MANDATORY service bulletin

M87-25
Supersedes M86-17

SUBJECT: **PISTON PIN REPLACEMENT AND THRU BOLT TORQUE CHECK**

AFFECTED: TSIO520BE - This engine is used on the Piper Malibu Aircraft
S/N 528001 through 528337

FIGURE A

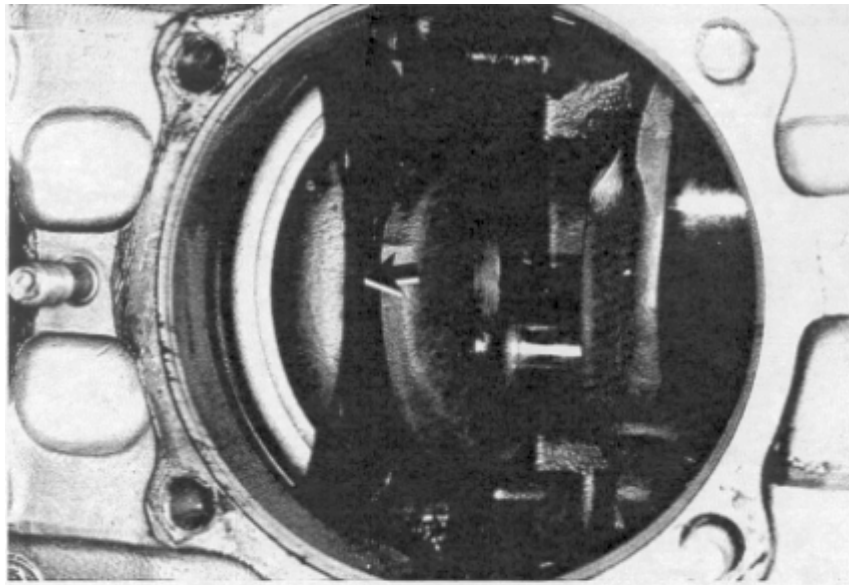
- B. With cylinders and pistons removed, visually inspect the number 1, 2, 3, and 4 crankcase main bearings for any signs of bearing rotation within the case; bearing movement fore or aft within the case or crankcase material distress. Particular attention should be given to number 2 and 3. The crankshaft should be moved fore and aft while performing this inspection. The crankshaft will also require rotation to allow for unobstructed view of the bearings.

Figure A depicts how bearing should generally appear.

FIGURE B
(Continued)

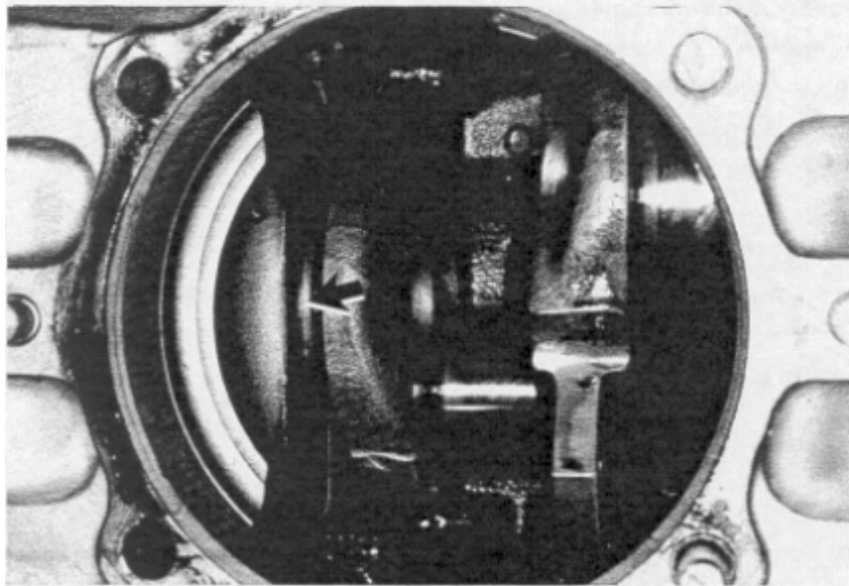
Figure B depicts a bearing that has shifted.

NOTE...Contact your local Teledyne Continental Motors representative (See Page 4) for disposition of any bearing appearing as in Figure B or with any signs of crankcase material distress.

FIGURE C

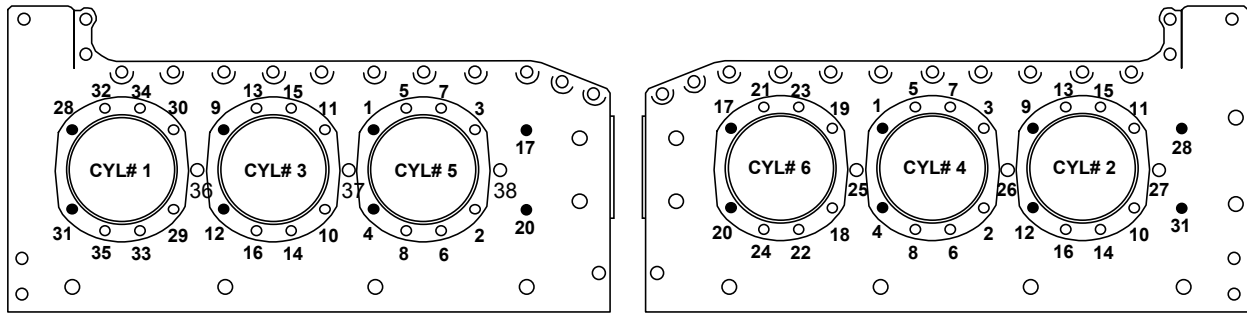
- C. If no problems are detected during the inspection outlined in paragraph IIB, proceed with the installation of new piston pins P/N 630046 and the reassembly of the engine.
- D. The cylinders should be installed in sequence and torqued in sequence per the instructions in Figure C. New cylinder gasket sets should be used, 6 each P/N 646565A1.

CAUTION...Before proceeding note that the six nuts utilized with the seventh stud (positions 25, 26, 27, 36, 37, 38) have a conical seat and can only be used in these positions.

1. Install cylinders 4 & 5. Tighten stud nuts (2, 3, 5, 6, 7, 8) and thru bolts (1 & 4) to 300-400 inch lbs. in sequence shown above.
2. Install cylinders 2 & 3. Tighten stud nuts (10, 11, 13, 14, 15, 16) and thru bolts (9 & 12) to 300-400 inch lbs. in sequence shown above.
3. Install cylinder #6. Tighten stud nuts (18, 19, 21, 22, 23, 24) and thru bolts (17 & 20) to 300-400 inch lbs. in sequence shown above.
4. Install cylinder #1. Tighten stud nuts (29, 30, 32, 33, 34, 35) and thru bolts (28 & 31) to 300-400 inch lbs. in sequence shown above.
5. Install 7th stud brackets & nuts (25, 26, 27, 36, 37, 38) and tighten to 300-400 inch lbs. (See Caution above).
6. Finish torquing thru bolts and stud nuts to their final torque values in sequence shown above.

INCH LBS.
Thru Bolts	1, 4, 9, 12, 17, 20, 28, 31	690-710
Stud Nuts	2, 3, 5, 6, 7, 8, 10, 11, 13 Thru 16, 18, 19, 21 Thru 27, 29, 30, 32, Thru 38	490-510

NOTE...Repeat torquing sequence with final torque values to insure that all thru bolts and stud nuts have been torqued.
